PORTION OF SE QUARTER OF SEC 27, TWN 20 N, RGE. 4 E, W.M.
CITY OF PUYALLUP, PIERCE COUNTY, WASHINGTON

No.	Date	By	Ckd.	Appr.	Revision
1	12/06/23	DL	DL	JSG	RESPONSE TO CITY COMMENTS, DATED 10-06-2023

Title: COVER SHEET
CIVIL PLANS
FORTRESS - PUYALLUP

Sheet C18 of 32

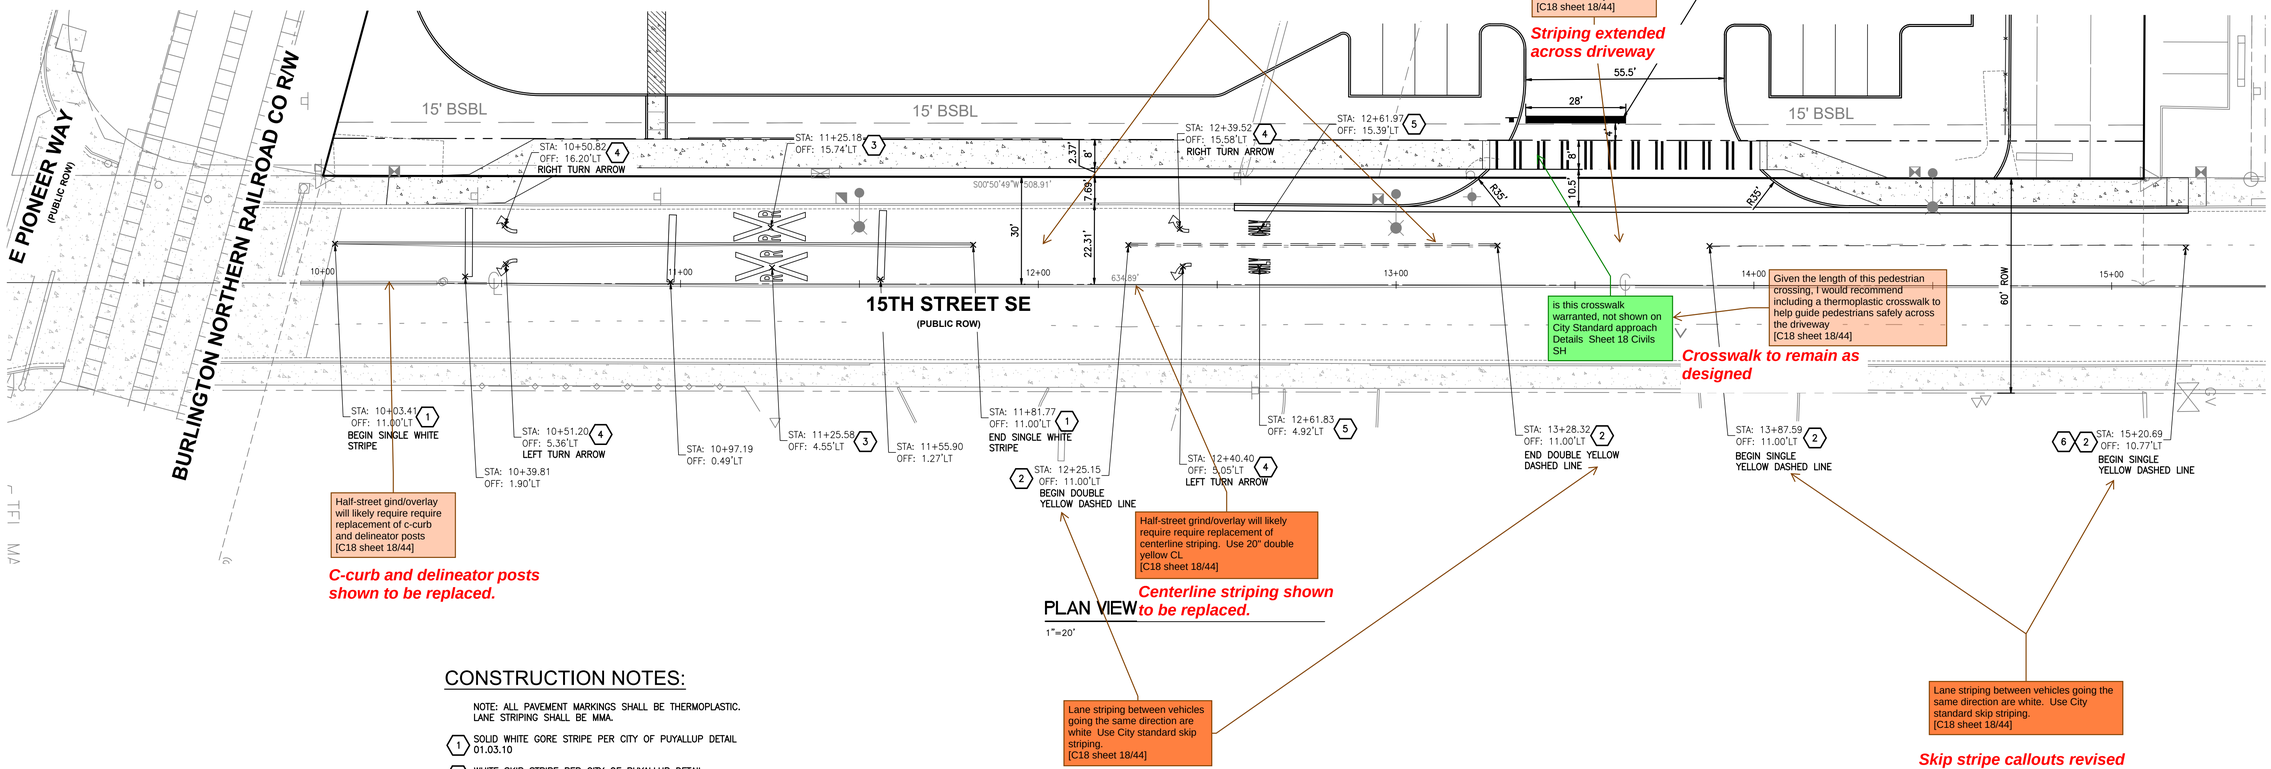
Use City standard skip striping in this area [C18 sheet 18/44]

provide lane striping across driveway [C18 sheet 18/44]

is this crosswalk warranted, not shown on City Standard approach Details Sheet 18 Civils SH

Given the length of this pedestrian crossing, I would recommend including a thermoplastic crosswalk to help guide pedestrians safely across the driveway [C18 sheet 18/44]

Half-street gind/overlay will likely require require replacement of c-curb and delineator posts [C18 sheet 18/44]

Half-street grind/overlay will likely require require replacement of centerline striping. Use 20" double yellow CL [C18 sheet 18/44]

Lane striping between vehicles going the same direction are white Use City standard skip striping. [C18 sheet 18/44]

Lane striping between vehicles going the same direction are white. Use City standard skip striping. [C18 sheet 18/44]

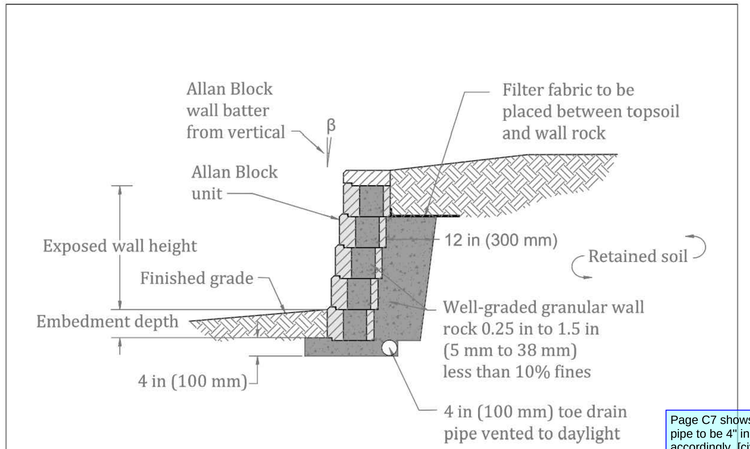
Page C7 shows the footing storm pipe to be 4" in diameter. Revise accordingly. [civils, Sheet C30]

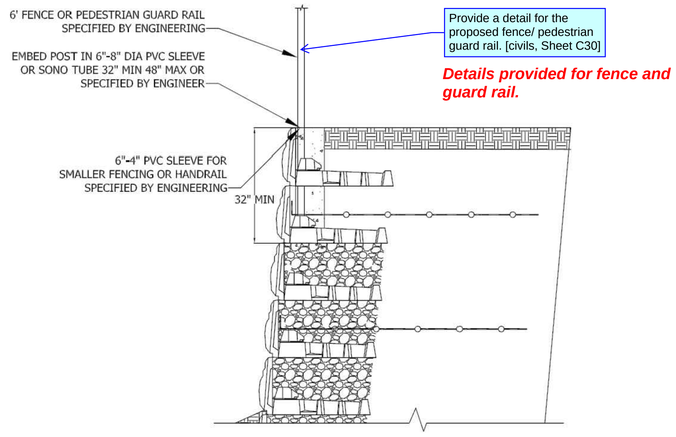
Provide a detail for the proposed fence/ pedestrian guard rail. [civils, Sheet C30]

Details provided for fence and guard rail.

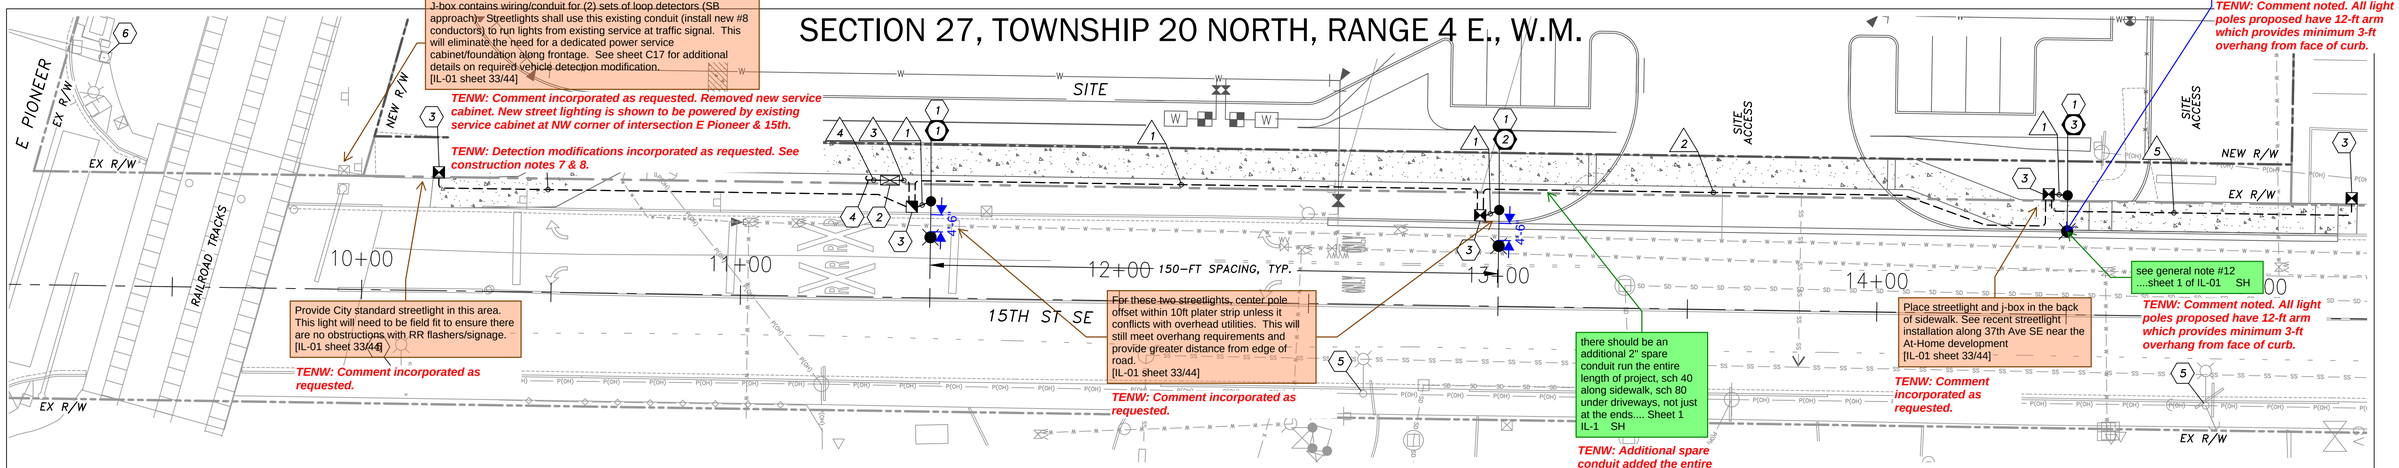
J-box contains wiring/conduit for (2) sets of loop detectors (SB approach). Streetlights shall use this existing conduit (install new #8 conductors) to run lights from existing service at traffic signal. This will eliminate the need for a dedicated power service cabinet/foundation along frontage. See sheet C17 for additional details on required vehicle detection modification. [IL-01 sheet 33/44]

Provide longer mast arm, the luminaire shall overhand the face of curb, a minimum of 3'. See city standard 01.05.04. [civils, sheet IL-01]

Provide City standard streetlight in this area. This light will need to be field fit to ensure there are no obstructions with RR flashers/signage. [IL-01 sheet 33/44]

For these two streetlights, center pole offset within 10ft plater strip unless it conflicts with overhead utilities. This will still meet overhang requirements and provide greater distance from edge of road. [IL-01 sheet 33/44]

there should be an additional 2" spare conduit run the entire length of project, sch 40 along sidewalk, sch 80 under driveways, not just at the ends.... Sheet 1 IL-1 SH

Place streetlight and j-box in the back of sidewalk. See recent streetlight installation along 37th Ave SE near the At-Home development [IL-01 sheet 33/44]

It is the sole responsibility of the design engineer to ensure streetlight design/placement is outside of the 10ft minimum safe zone area from PSE primary. [IL-01 sheet 33/44]

Streetlights shall have shorting caps installed. ~~Remote photocell located on signal cabinet~~ [IL-01 sheet 33/44]

TENW: Comment noted. All light poles proposed have 12-ft arm which provides minimum 3-ft overhang from face of curb.

1 L1.10 PLANTING PLAN EAST

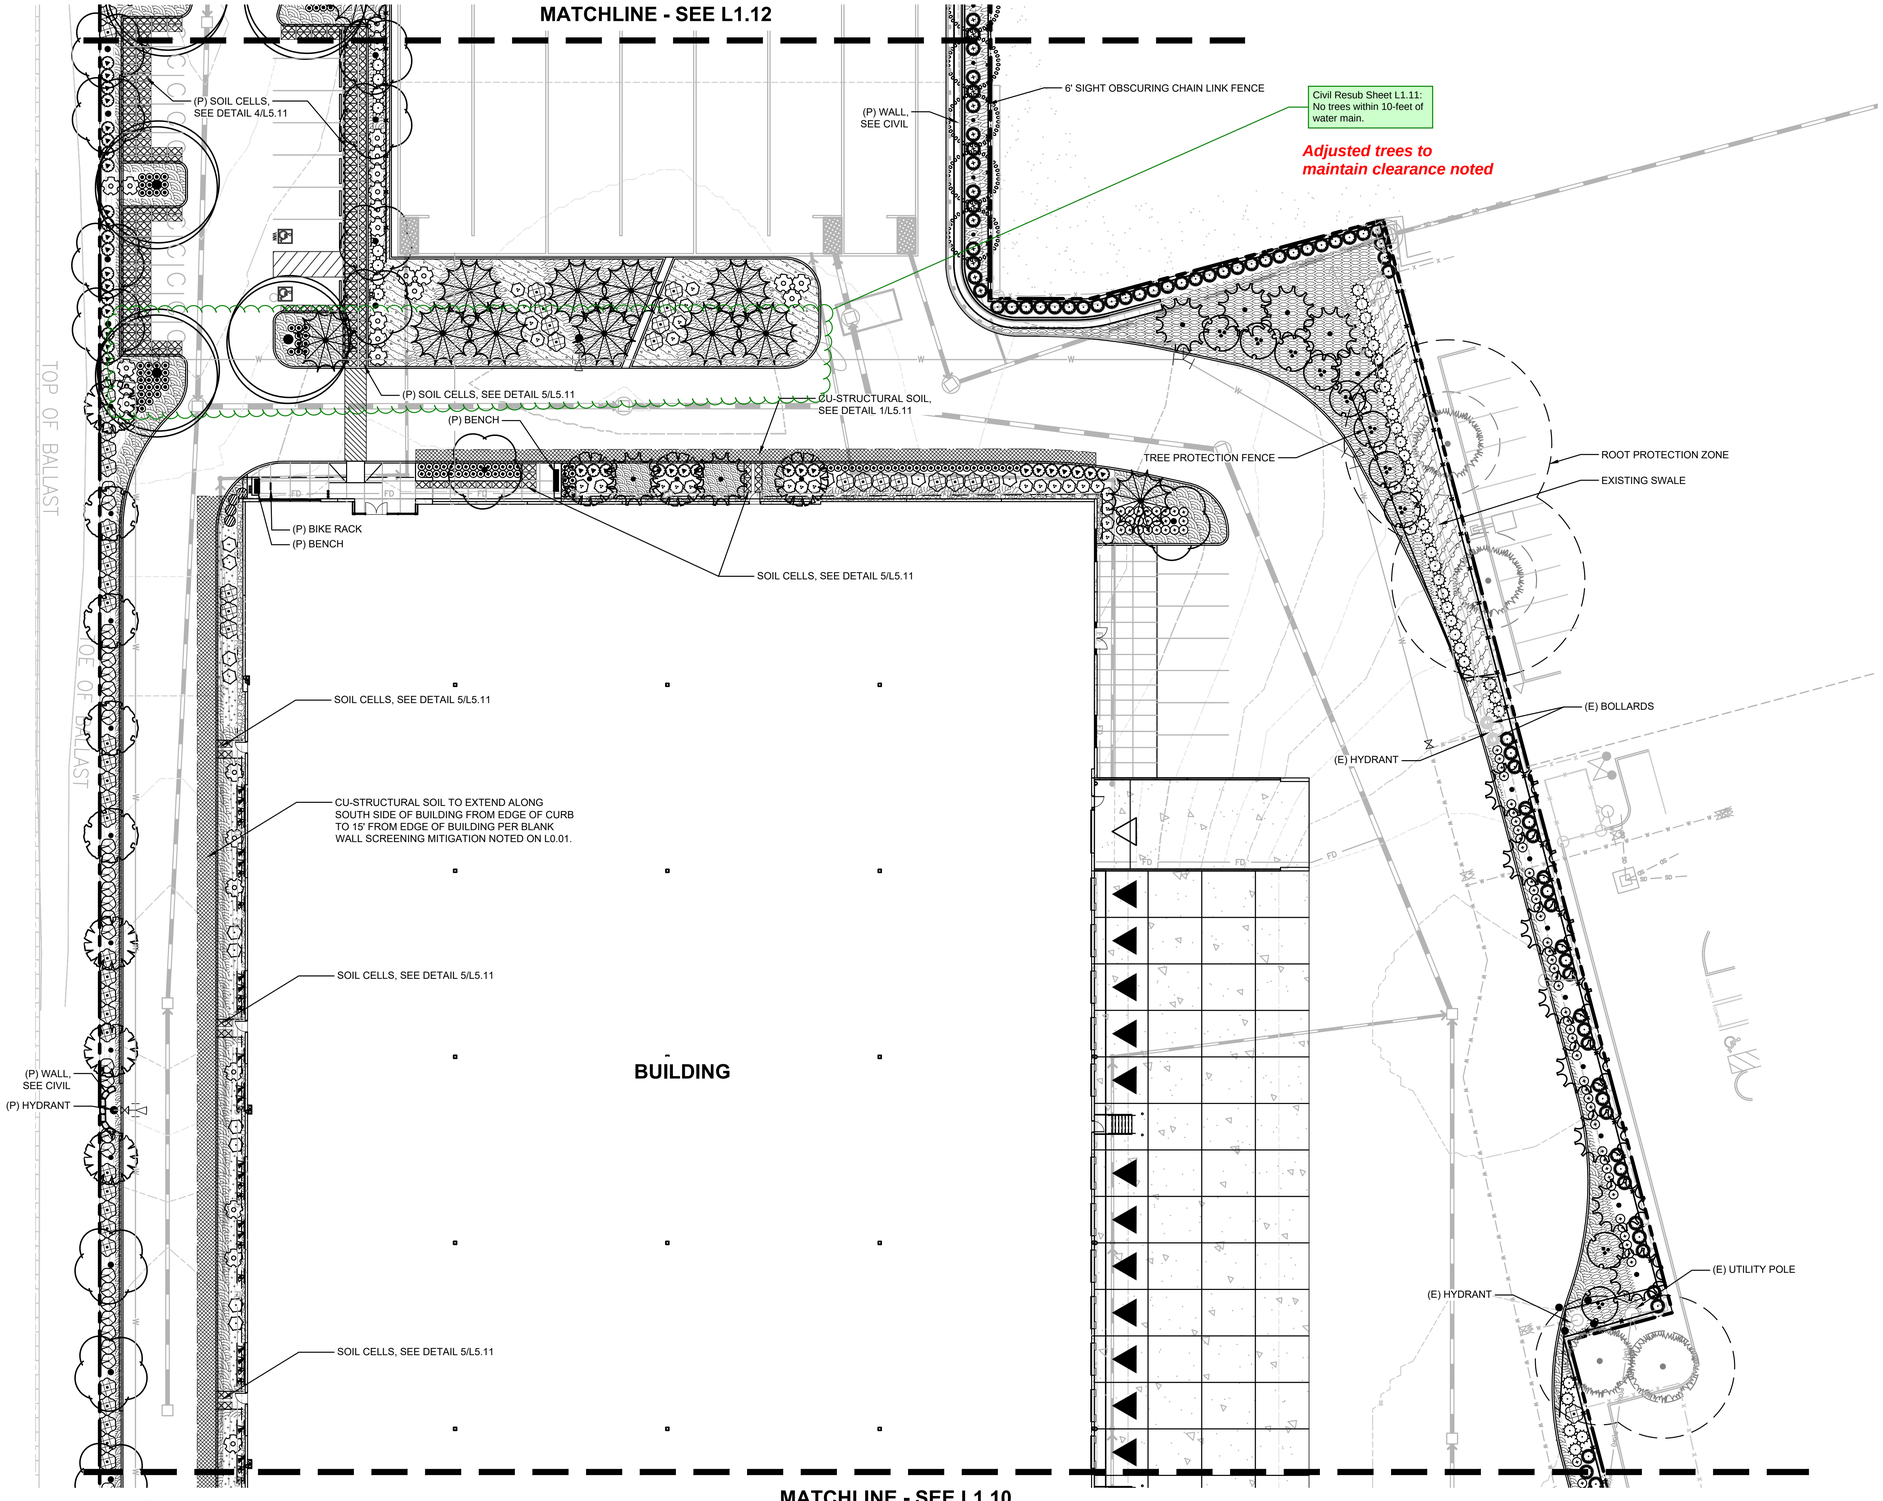
Civil Resub Sheet L1.10: No trees within 10-feet of a fire line. Provide 3-foot clear zone around PIV.

Verify asphalt removal [L1.10 sheet 36/44]

what planting detail is used along the right of way, L5.11 , L5.13 or L5.14....it should be the soil cells L5.11 and should note this somewhere....L1.10 SH

Show entering sight lines from previous analysis. Some street trees in planter may need to be removed due to interference with truck sight lines. [L1.10 sheet 36/44]

Added soil cell breakout zones at street trees (5/L5.11). The City Street tree planting detail (1/L5.14) applies to the street trees.
